# EIR Addendum

## Berth 136-147 [TraPac] Container Terminal Project

*Prepared by Los Angeles Harbor Department  
Environmental Management Division  
June 6, 2012*

Attachment B

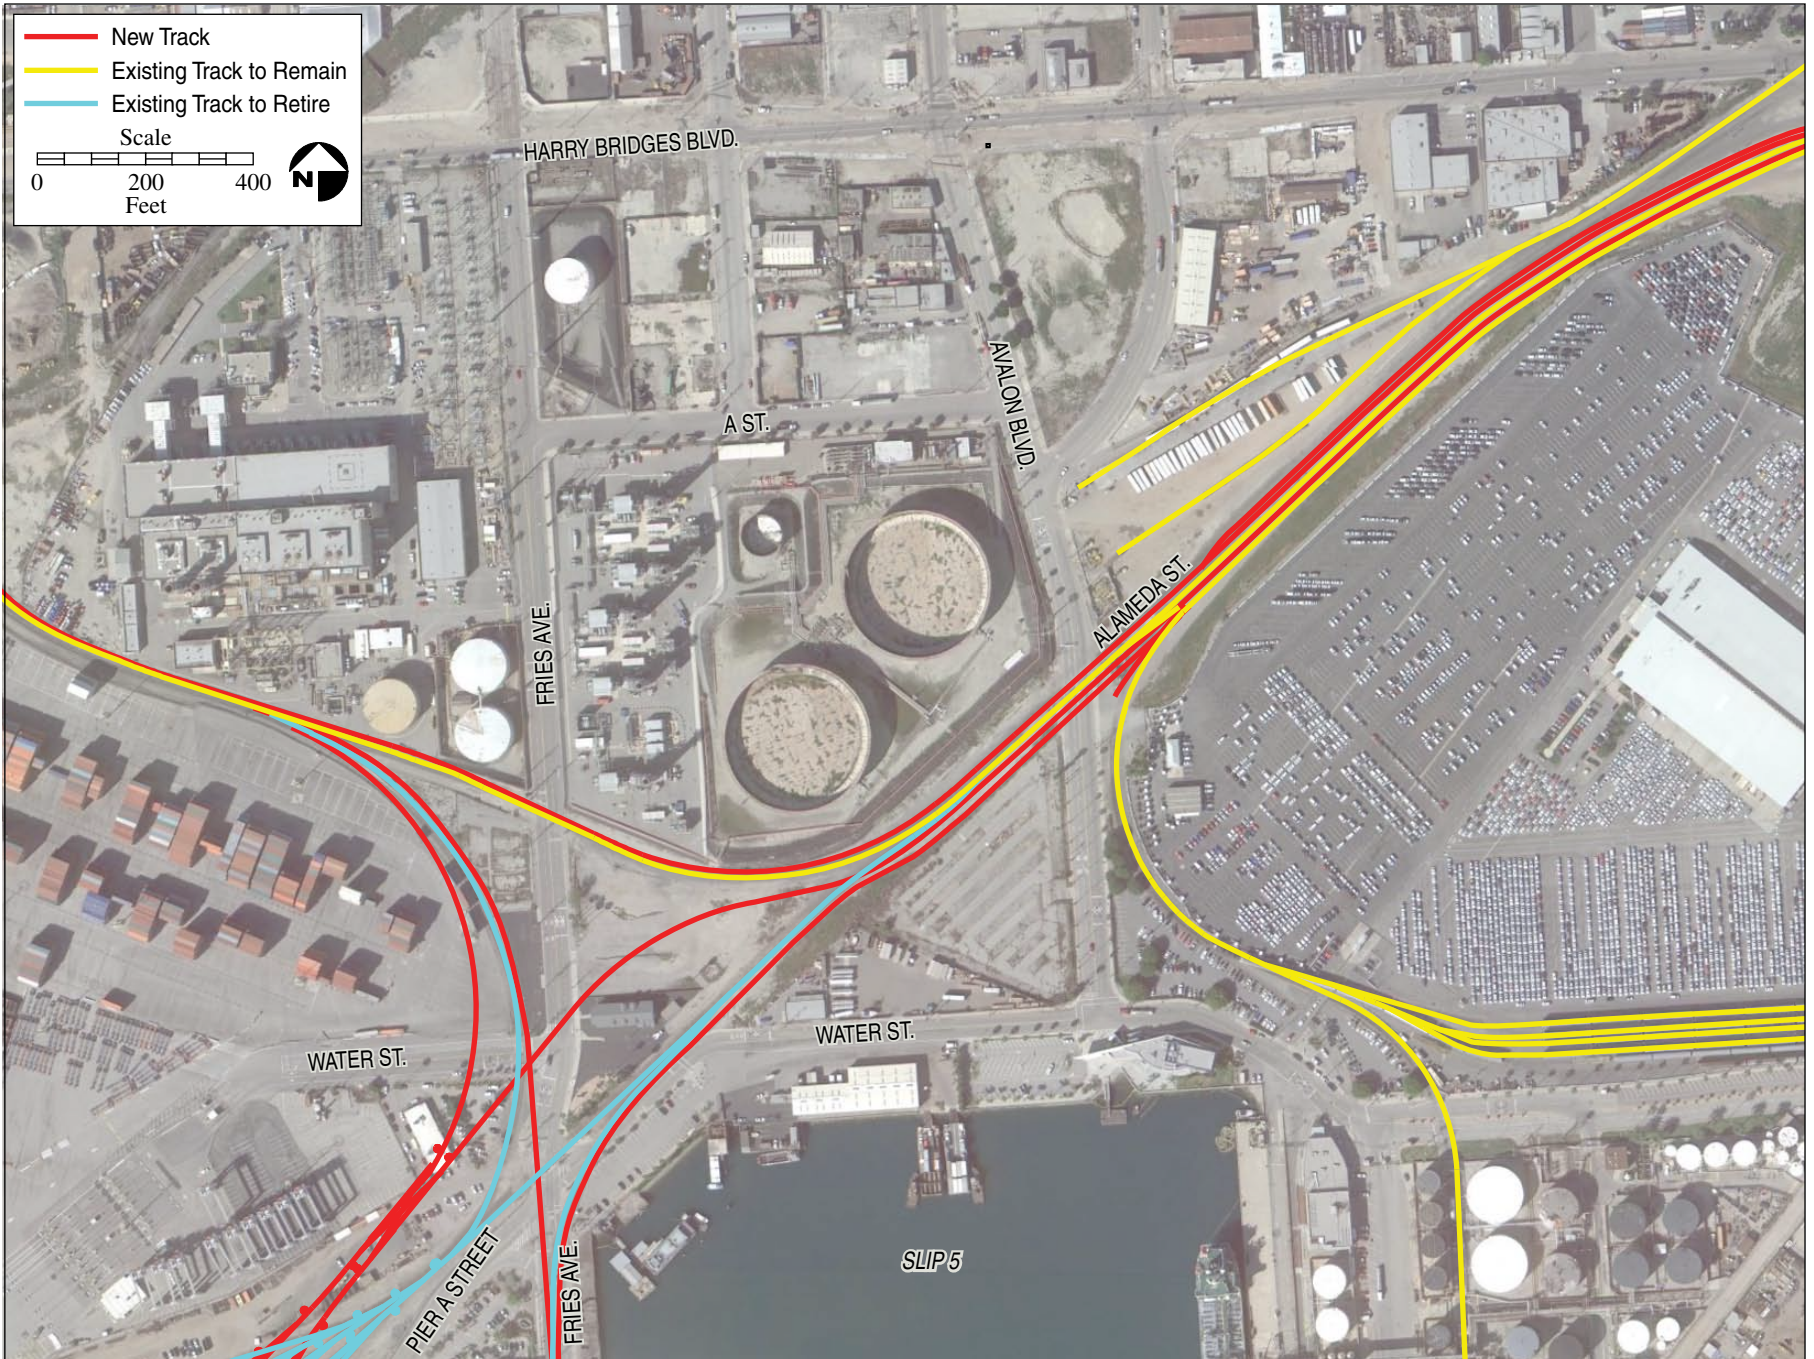
foot maintenance shed. The relocation of the rail yard would also include the construction of new rail tracks to connect the relocated yard to the TraPac terminal and the removal of some existing tracks (Attachment B). The rail track configuration between TraPac and the Pier A Rail Yard includes four tracks crossing Avalon Boulevard (one existing and three new). It also includes four tracks across Fries Avenue (one existing and three new) and three across Water Street (all new).
